### ADDENDUM 1

CSP 22-92

## Cavazos Elementary School Heating & Air Condition (HVAC) Improvements Funded through the Elementary & Secondary Emergency Relief (ESSER) Funds May 31, 2022

## Addendum

**M2.14D**

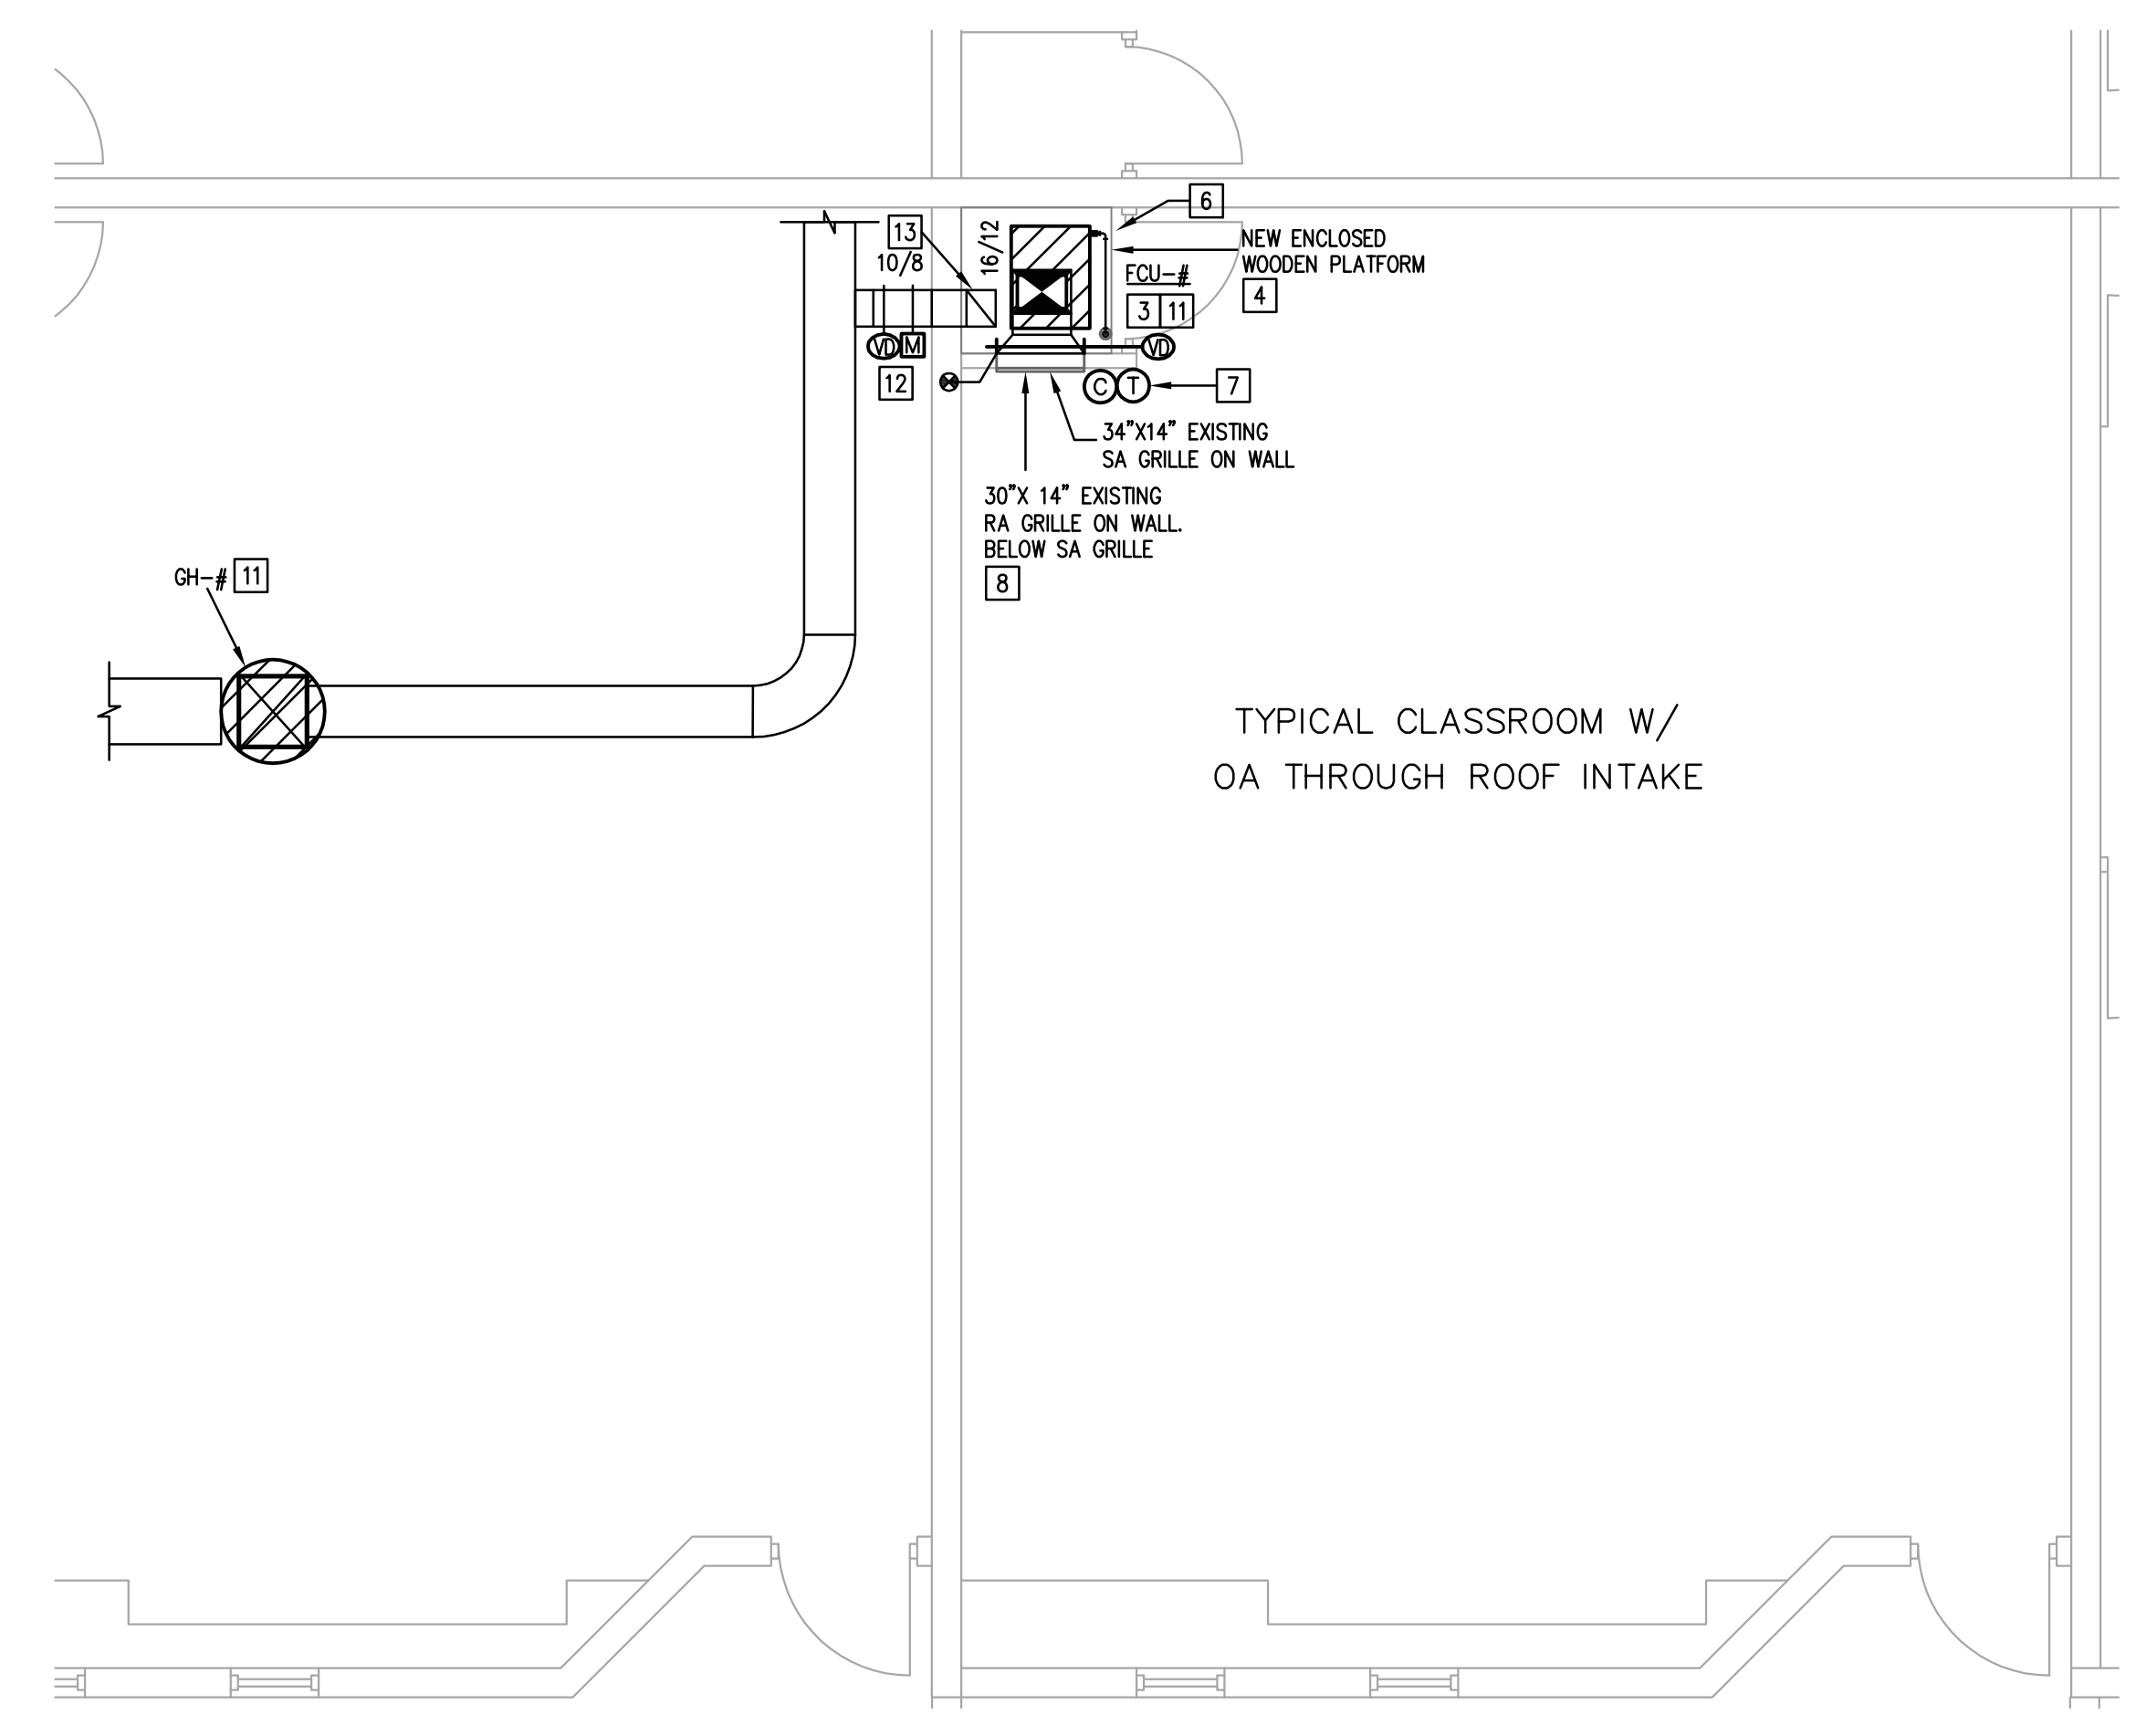
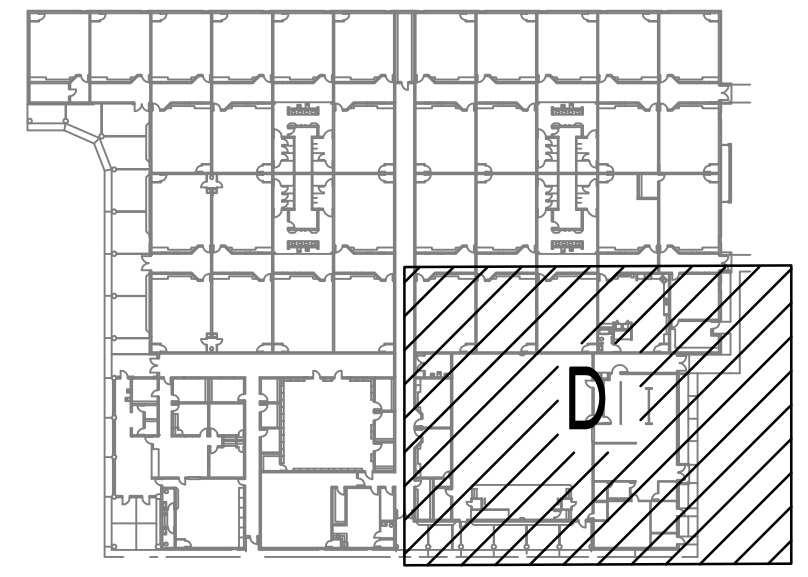
**Item 08 M2.14D – Level 1 Mechanical Plan – Area D**

- A. Revised keyed notes 7, 12, 15.
- B. Indicate condensate piping for RTU-1 and RTU-2.
- C. Added H'stat for RTU-1 and RTU-2.

DATE: 05/05/2022  
 DRAWN BY: DBR  
 CHECKED BY: DBR  
 PROJECT NUMBER: 218007.005  
 SHEET TITLE: LEVEL 1 ELECTRICAL POWER PLAN - DEMOLITION - AREA A  
 SHEET NUMBER: EPD2.11A

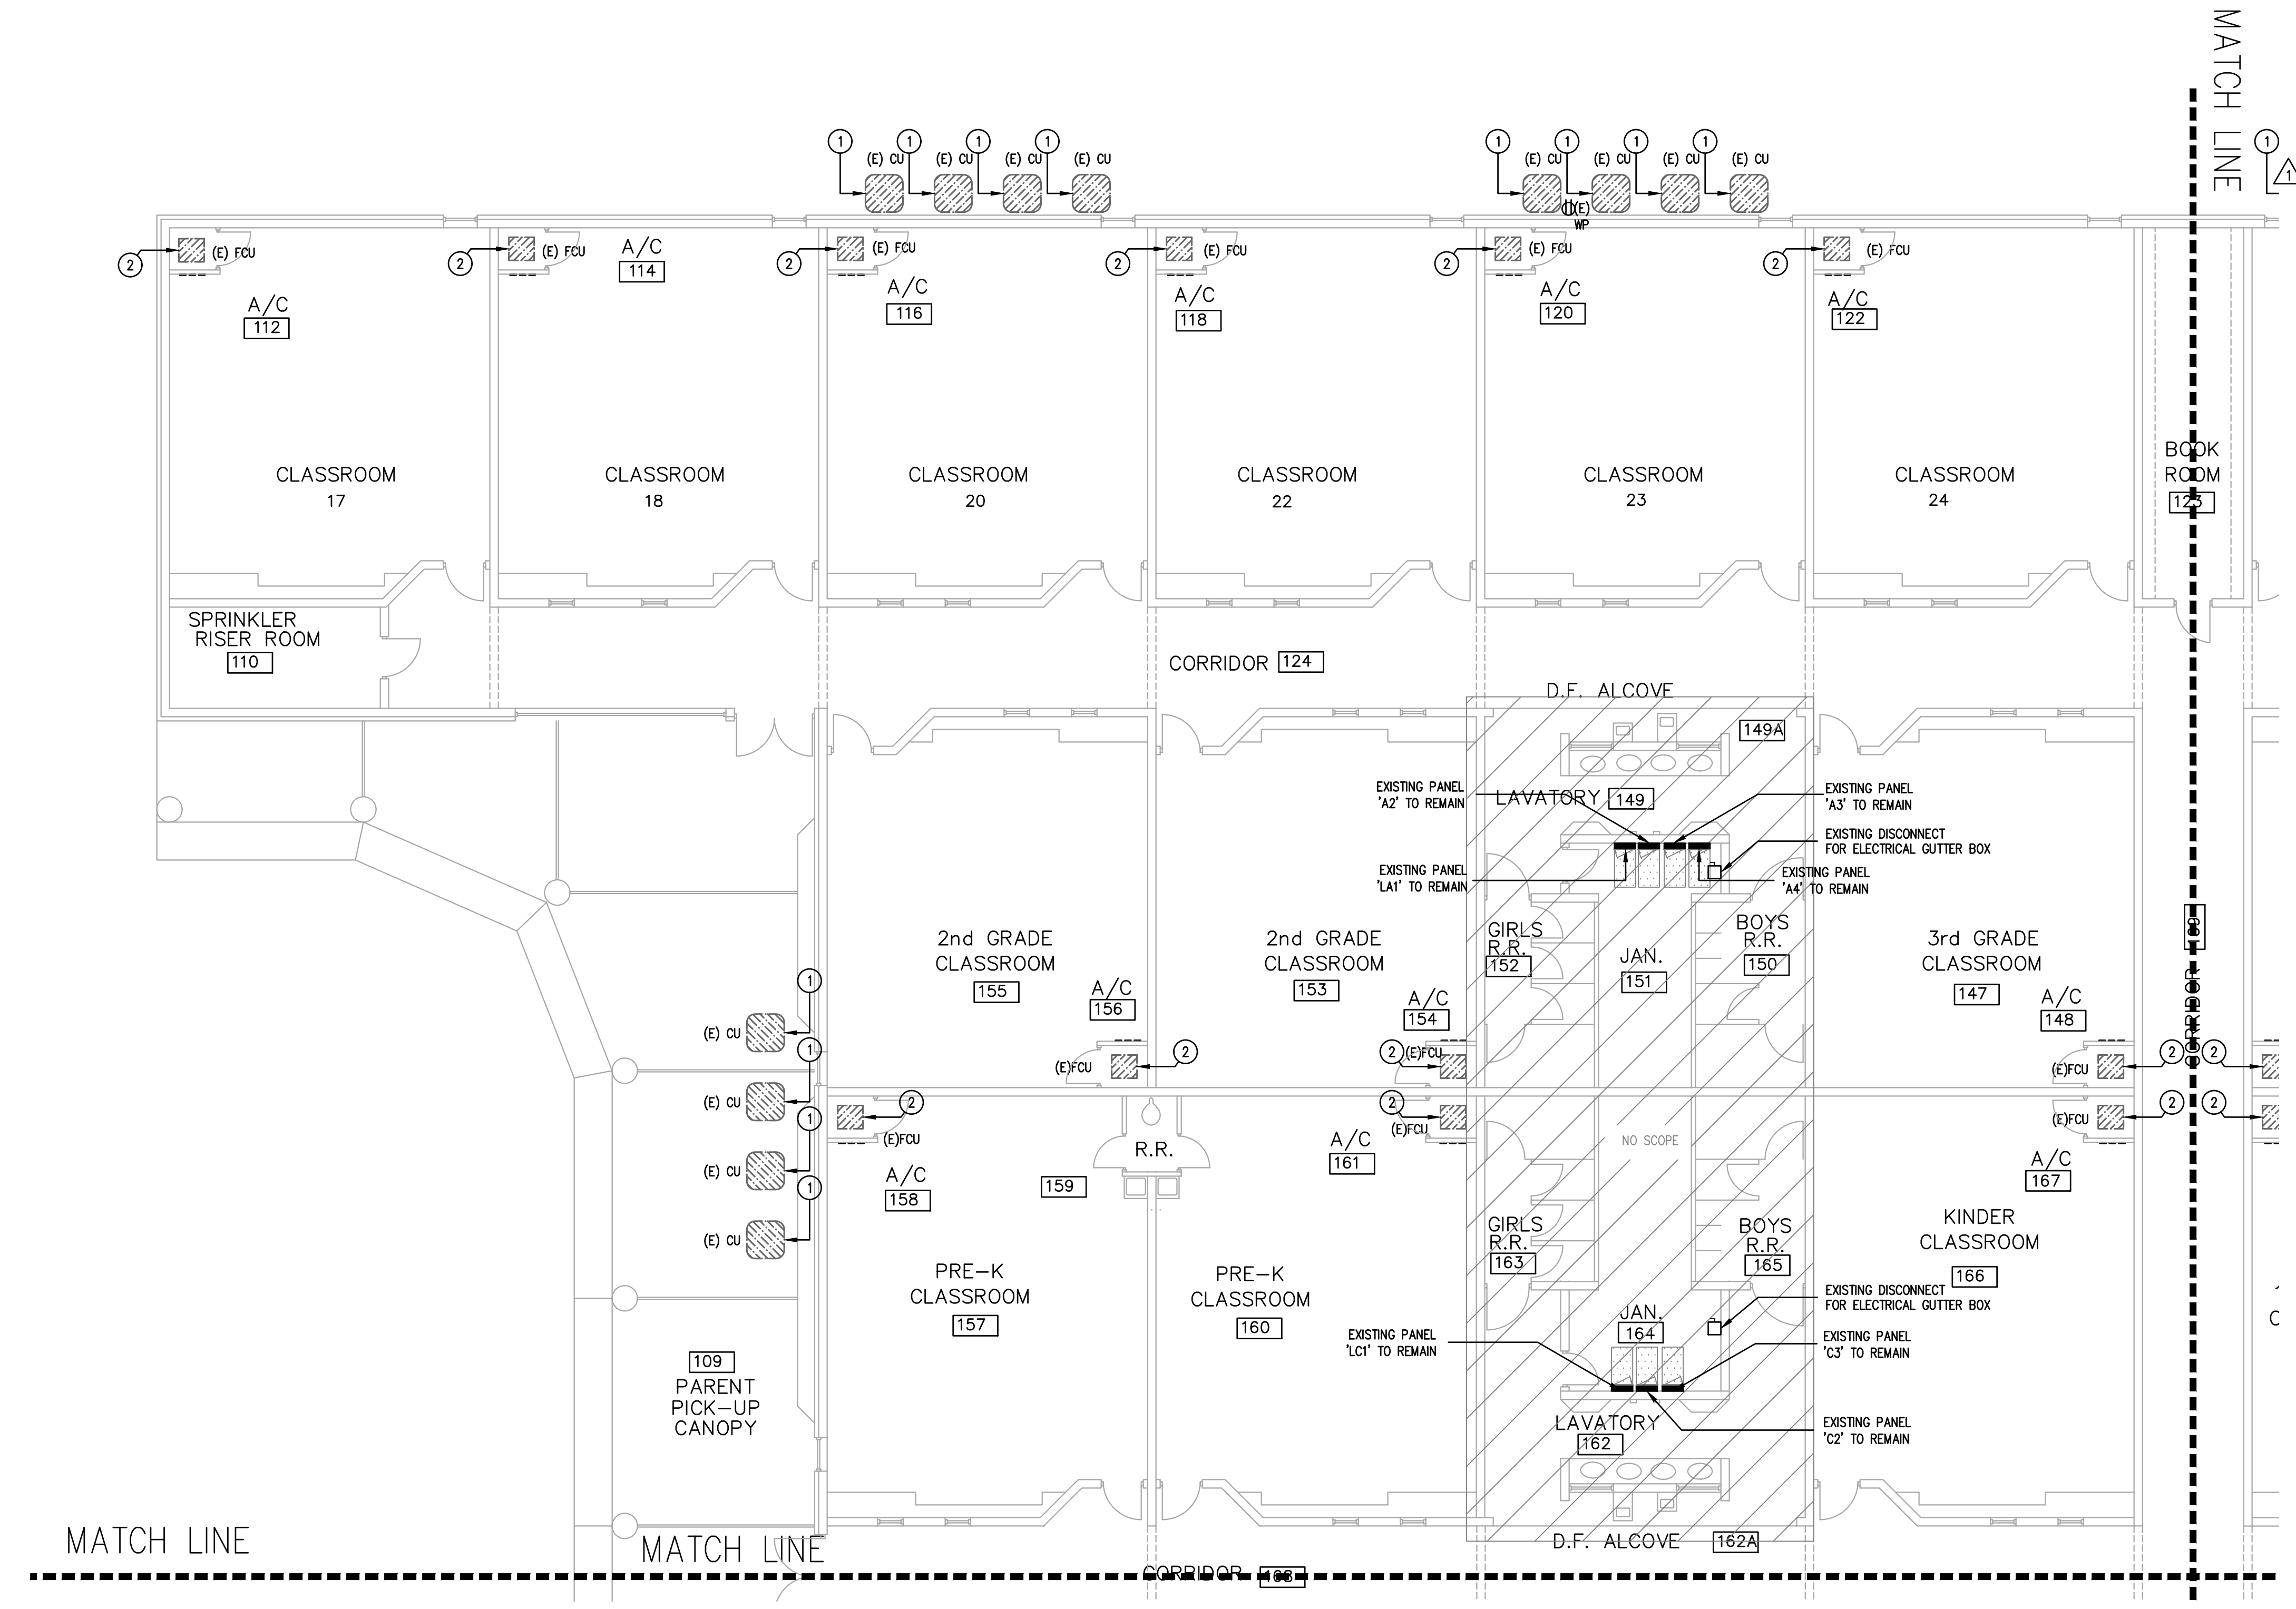
**Item 12 EPD2.11A – LEVEL 1 ELECTRICAL POWER PLAN – DEMOLITION – AREA A**

- A. Revised keyed note 2.
